Subject: DETROIT™ Reman Built HDEP Engines - Incorrect Gear Train Bolt Torque
Models Affected: Certain DETROIT™ Reman Built HDEP Engines

Daimler Trucks North America LLC, on behalf of its DETROIT™ Powertrain Division, is initiating Field Service Campaign D20M6 to modify the vehicles mentioned above.

Subject: **Field Service Campaign D20M6**

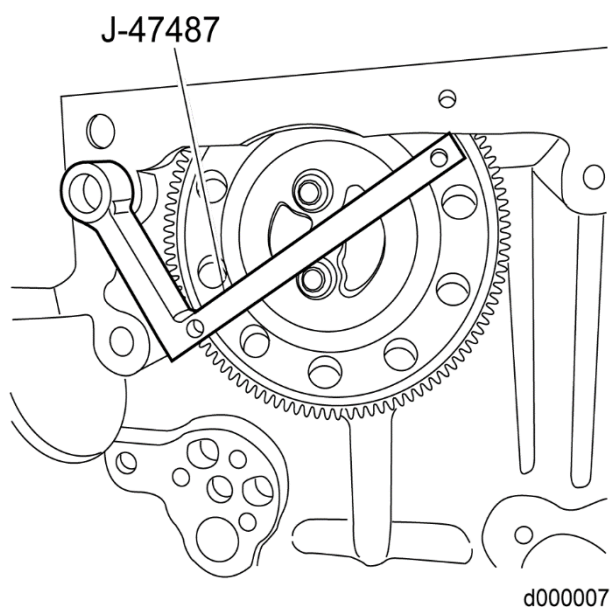
2. Disconnect the batteries. Refer to the Original Equipment Manufacturer (OEM) procedure.
3. Open the hood.
4. Remove the flywheel housing. Refer to section "Removal of the Flywheel Housing"
5. Rotate the crankshaft so the pistons in cylinders 1 and 6 are at Top Dead Center (TDC), if not already positioned. The locating pin for the crankshaft gear should be at the 12 o'clock position.
6. Install and lock crankshaft TDC locating tool (J-48630) into place with a flywheel mounting bolt. See figure below.
